Clinton Power Station, Unit 1  
Facility Operating License No. NPF-62  
NRC Docket No. 50-461

Subject: Third Six-Month Status Report in Response to March 12, 2012 Commission Order Modifying Licenses with Regard to Reliable Spent Fuel Pool Instrumentation (Order Number EA-12-051)

**Third Six-Month Status Report for the Implementation of Order EA-12-051, Order  
Modifying Licenses with Regard to Reliable Spent Fuel Pool Instrumentation**

Attachment 1 – CPS Schematic of the level Sensor with Mechanical Attachment Points

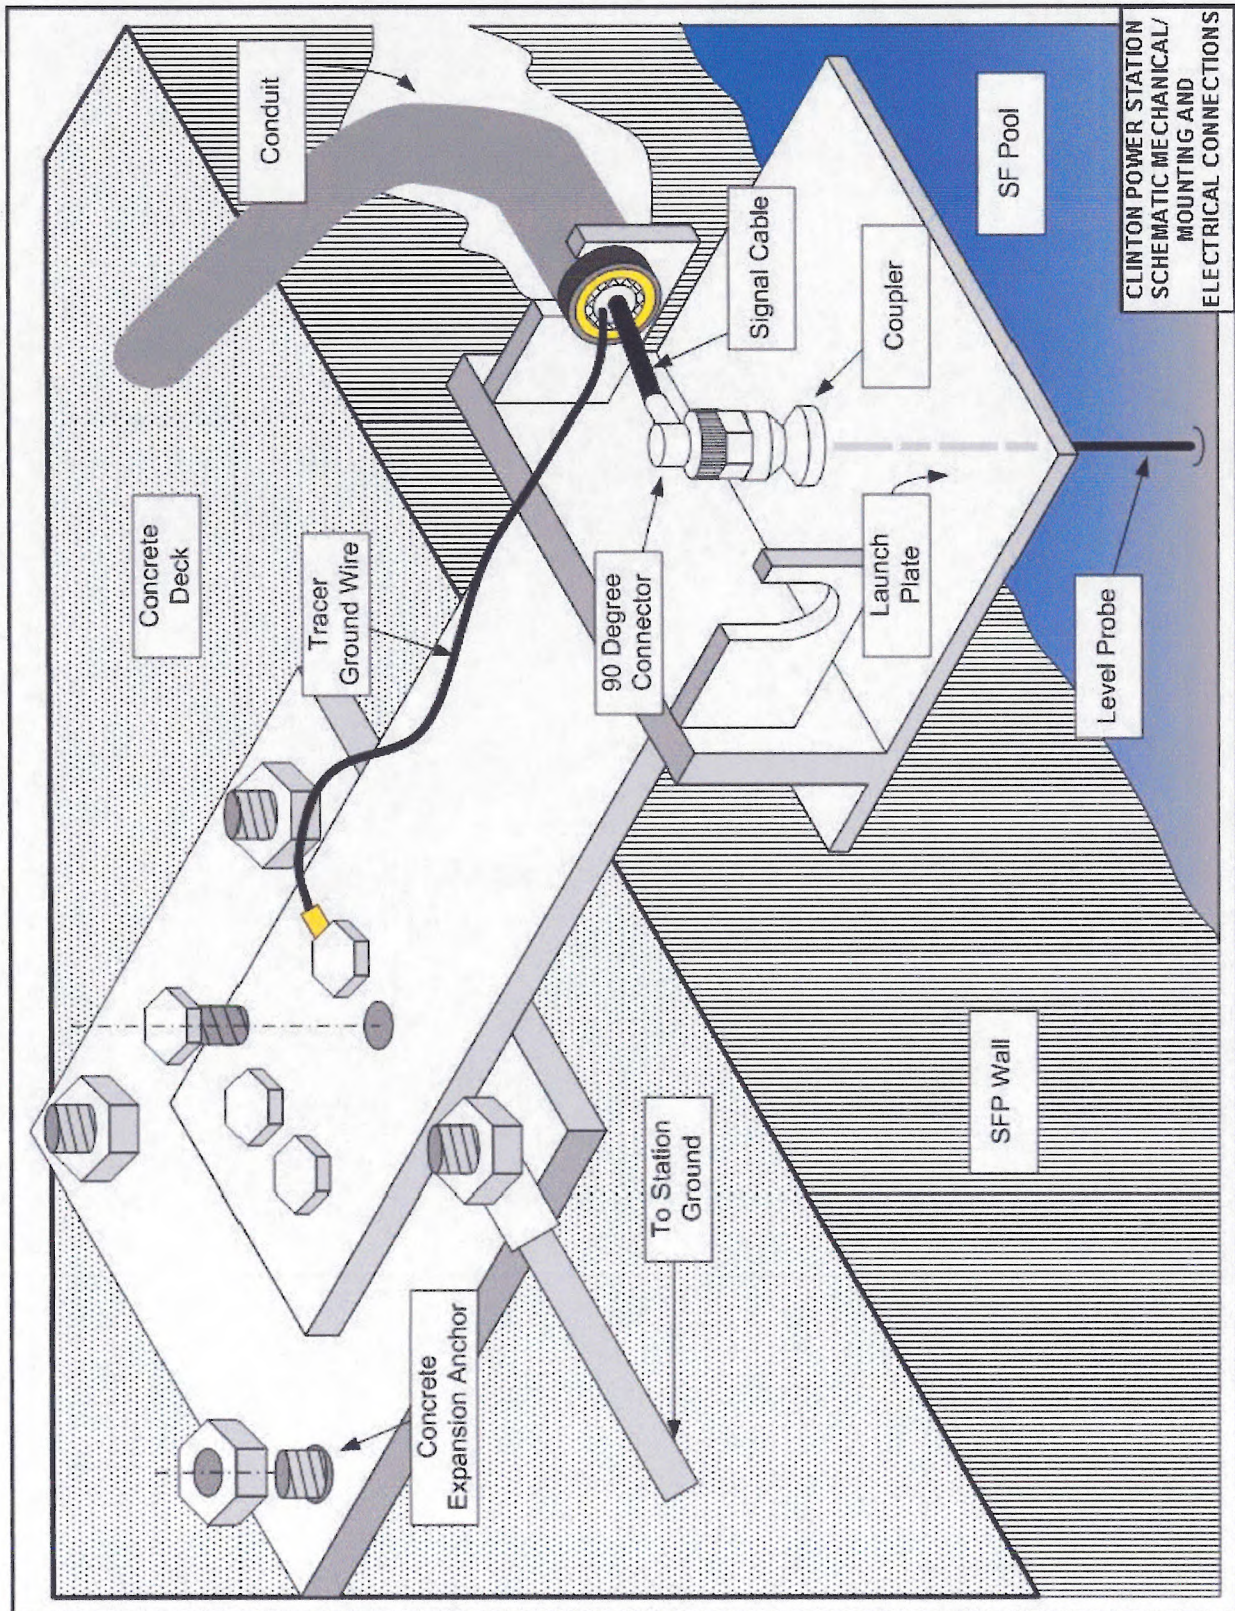
<p>for the portions of instrument channel consisting of permanent measurement channel equipment (e.g., fixed level sensors and/or stilling wells, and mounting brackets). Indicate on this sketch the datum values representing Level 1, Level 2, and Level 3 as well as the top of the fuel racks. Indicate on this sketch the portion of the level sensor measurement range that is sensitive to measurement of the fuel pool level, with respect to the Level 1, Level 2, and Level 3 datum points.</p>	
<p>2 (RAI -2,</p>	<p><u>RAI Question:</u> Please provide a clearly</p>	<p><u>Complete</u> Provided in the attached preliminary sketch "NRC RAI Question 1". NOTE: The method of grounding the bracket assembly may deviate</p>

**NRC RAI Question 1**  
 PAGE 2 OF 3  
 CLINTON POWER STATION  
 SPENT FUEL POOL LEVEL INDICATION PROJECT  
 PLANNED CABLE PATHS AND COMPONENT  
 LOCATION SKETCH

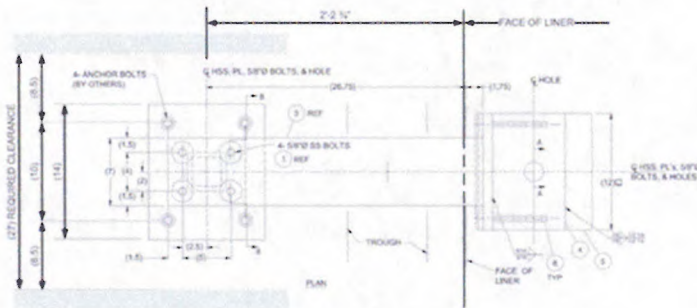
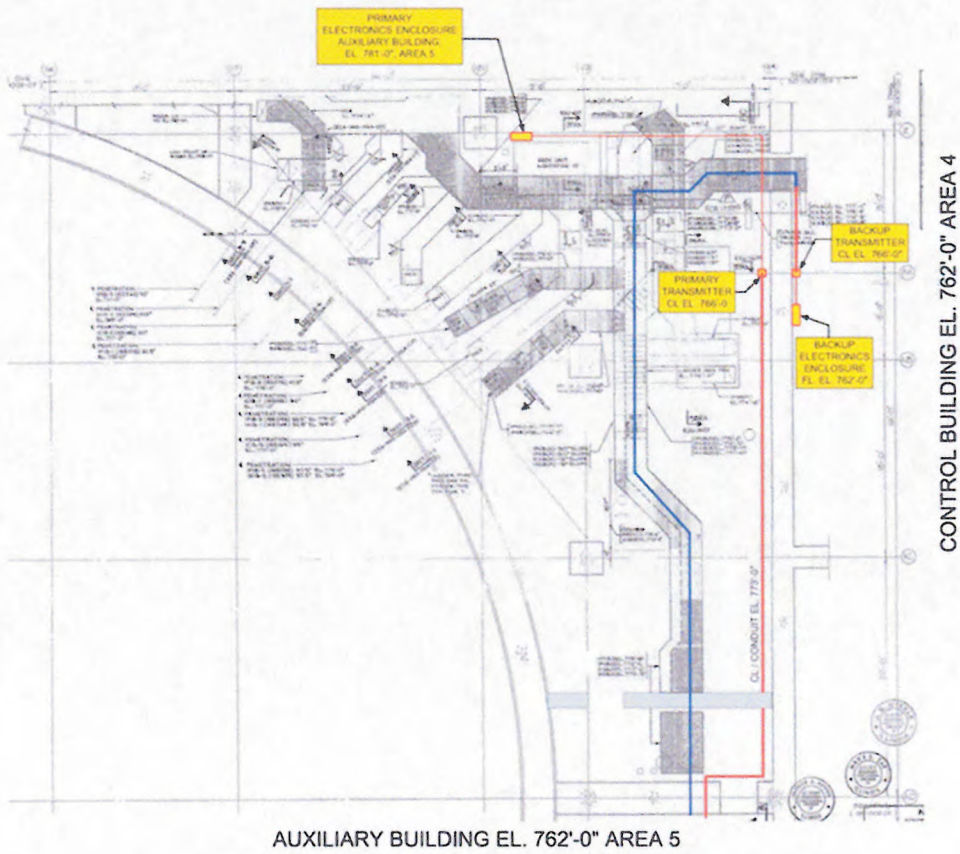
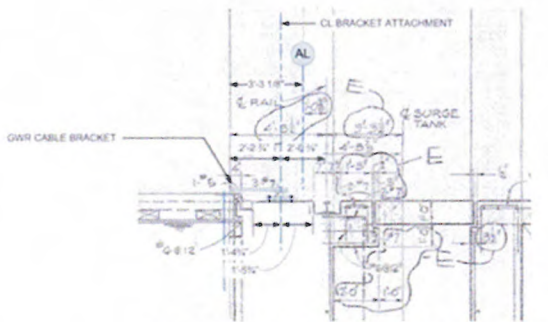
<p>Ref. 4)</p>	<p><b>labeled sketch or marked-up plant drawing of the plan view of the SFP area, depicting the SFP inside dimensions, the planned locations/place ment of the primary and backup SFP level sensor, and the proposed routing of the cables that will extend from the sensors toward the location of the read-out/display device.</b></p>	<p>from this sketch when further installation/design details are developed.</p>
<p>3 (RAI -3, Ref. 4)</p>	<p><b>RAI Question:</b> <b>Please provide the following:</b> <b>a) The design criteria that will be used to estimate the total loading on the mounting device(s), including static weight loads and dynamic loads. Describe the methodology that will be used to estimate the</b></p>	<p><b><u>Started</u></b></p> <p>a) All Spent Fuel pool Instrumentation (SFPI) equipment will be designed in accordance with the Clinton Power Station (CPS) Safe Shutdown Earthquake (SSE) design requirements.</p> <p>The vendor, Westinghouse, is currently evaluating the structural integrity of the mounting brackets in calculation CN-PEUS-14-13. The GTSTRUDL model will be used by Westinghouse to calculate the stresses in the bracket assembly. This considers load combinations for the dead load, live load and seismic load on the bracket. The reactionary forces calculated from these loads become the design inputs to design the mounting bracket anchorage to the refuel floor to withstand a Safe Shutdown Earthquake (SSE).</p> <p>Seismic</p> <p>The seismic loads are obtained from the Clinton Power Station response spectra curves (Reference Updated FSAR Chapter 3 Figures 3.7 for CPS). The following methodology will be used in</p>
